Product hierarchy no. *	Part no.	SBU	Type / Description	Customer part no.
SBU PG PGU Type			·	·
04 000 000 0000000000	O 1:-4 h - 1	Enterplated and the second sec	CCD	
01 002 002 0000000509	See list below	Fuseholder	FEP

# 3 Detailed description of change

Product Change Notification					PCN Type FEP		
owner	creation date	release date	released by	change order no	rev	page	D40 000 025
zbindeja	2016-06-30	2016-06-30	zbindeja	2010418	В	1 of 2	D10-000-835

#### 1 Products affected

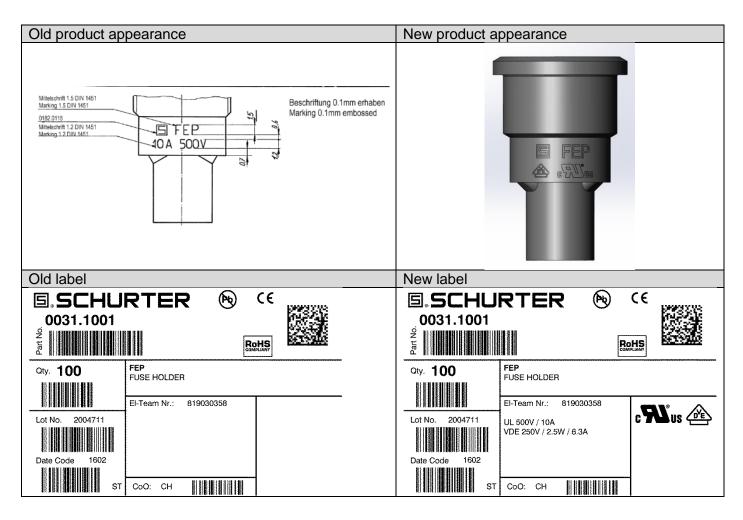
List of part numbers affected						
FEP complete						
0031.1001	0031.1015	0031.1026	0031.1071	0031.9822		
0031.9829						
FEP socket			<u> </u>			
0031.1005	0031.1072					
FEP carrier		·				
0031.1028	0031.1028.Z

- 1. Modification of approval marks
- 2. Modification of label
- 3. Material change
- 4. Adjustment of technical ratings

Old product rating	New product rating
500 V (SEV and VDE) / 380 V (VDE)	250 VAC (VDE), 500 V (UL/CSA)
10 A (SEV)	6.3 A (VDE), 10 A (UL/CSA)
2.5 W / 6.3 A @ T <sub>a</sub> 23 °C (VDE)	2.5 W / 6.3 A @ T <sub>a</sub> 23 °C (VDE)
_	
Old product approval	New product approval
VDE	VDE
	cURus

- Recertification by VDE
- Product improvement to fulfil the enhanced glow wire requirements according to the updated standard IEC 60127-6 and the standard IEC 60335-1 for appliances in unattended use.
- New approval by cURus.

Form	No	There are no form changes, only markings adjusted.
Fit	No	There are no dimensional changes.
Function	Yes	Change of rated voltage (VDE).
<b>Production Site</b>	No	There is no change of the production site.
Product Label	Yes	VDE and cURus marks added. Electrical ratings added.
<b>Customer Action</b>	Yes	Please consider the electrical ratings.
